**ADDENDUM NO. 1** (4 pages)

**Solicitation: Invitation for Bid: #20-016-SE Brick Paver Sidewalk Construction – Tucker Store Pocket Park**

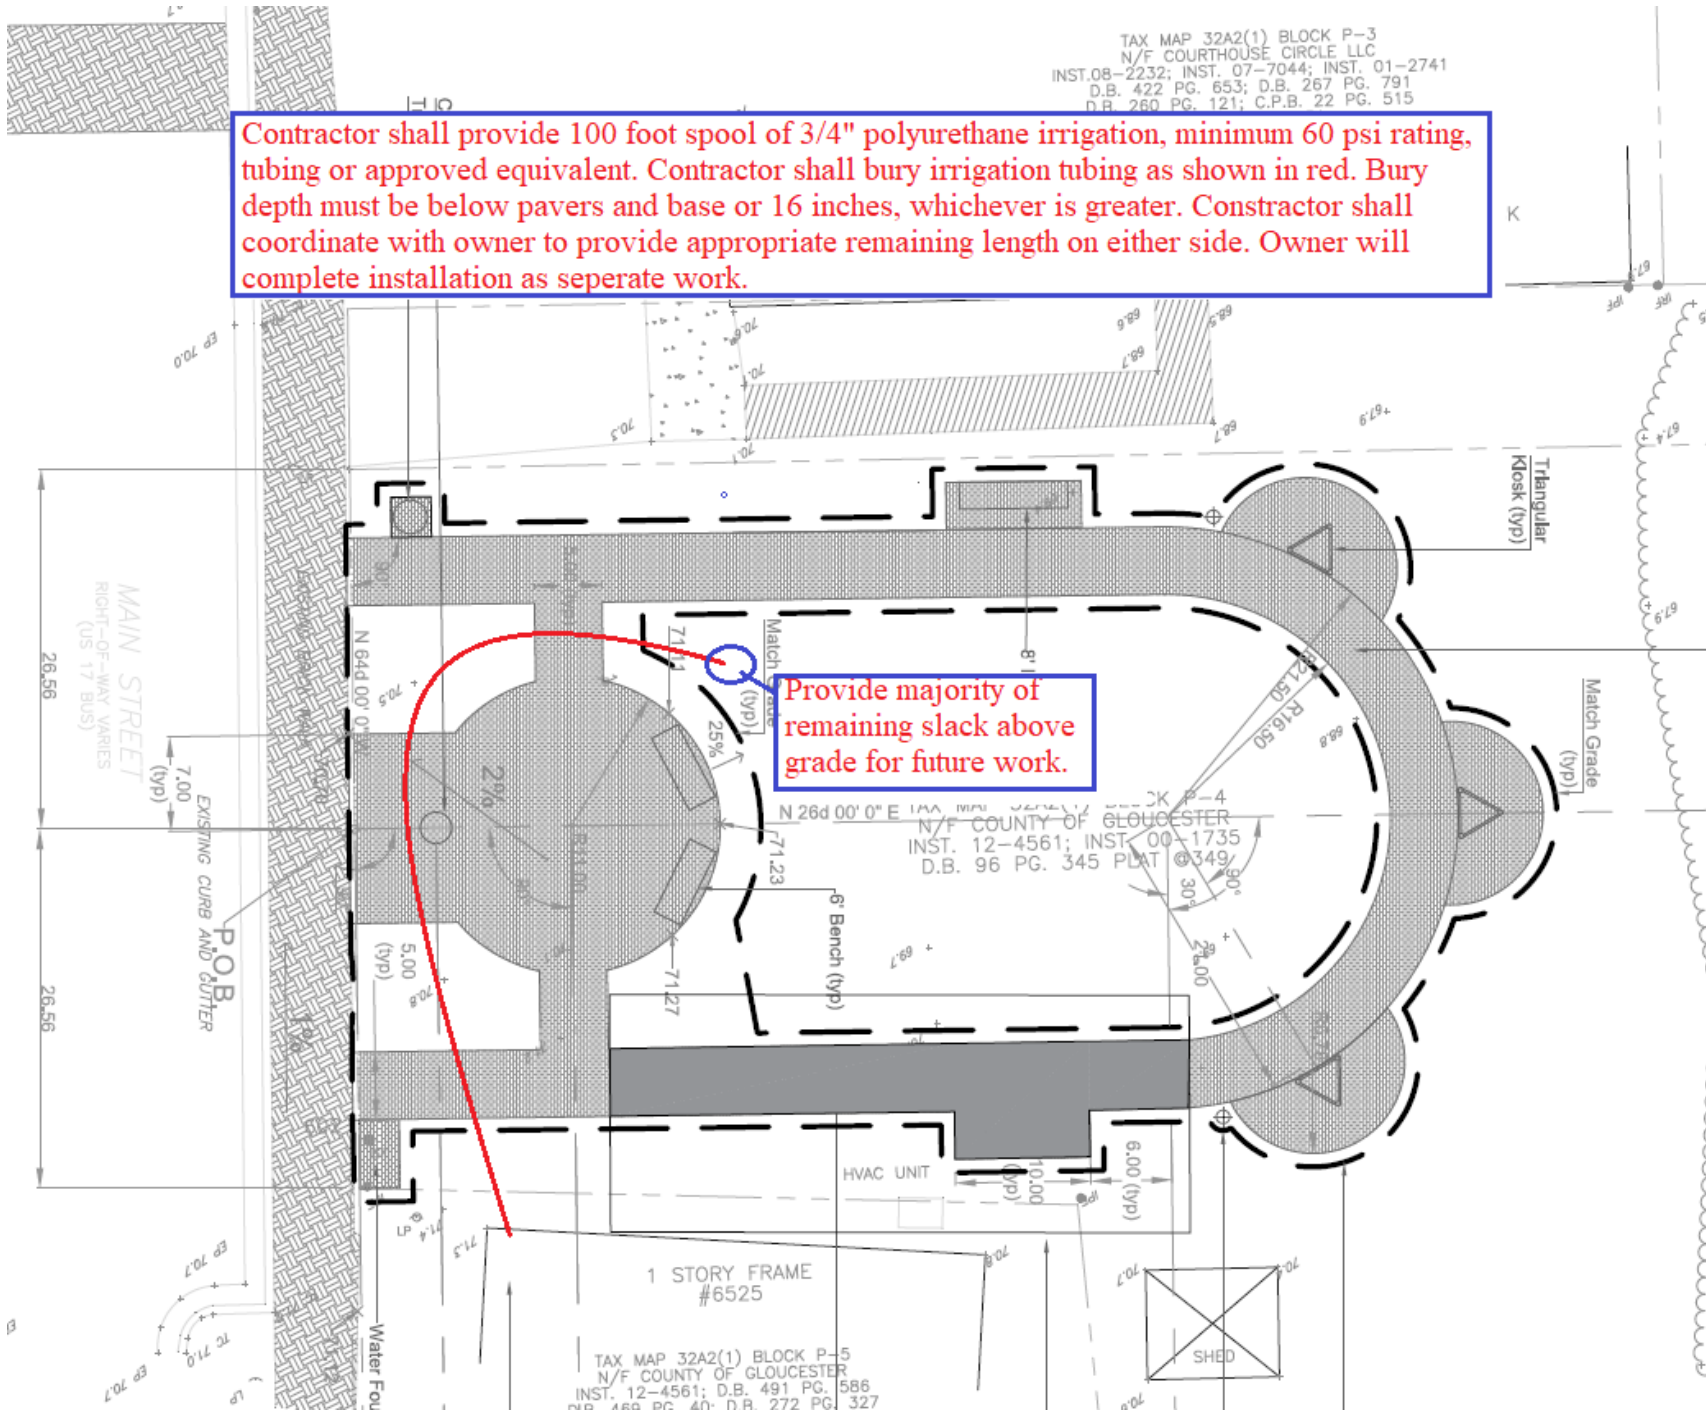
- 2. Question:** IFB Scope of work states that all site furnishing are to be procured by “Owner” and installed by “Contractor”.  
Is the contractor responsible for installation of the water and electric utilities? If so, additional description information needs to be provided as to the size, type, connection area, possible building penetration, etc. In order to accurately assess the cost on this. A Utility drawing would be helpful.

- Potable water service to the drinking water fountain.
- Electrical service to the lights, clock tower and other furnishings as needed.
- An irrigation line as show in the attached drawing. No service connections required.

Contractor shall provide 100 foot spool of 3/4" polyurethane irrigation, minimum 60 psi rating, tubing or approved equivalent. Contractor shall bury irrigation tubing as shown in red. Bury depth must be below pavers and base or 16 inches, whichever is greater. Contractor shall coordinate with owner to provide appropriate remaining length on either side. Owner will complete installation as separate work.

Provide majority of remaining slack above grade for future work.
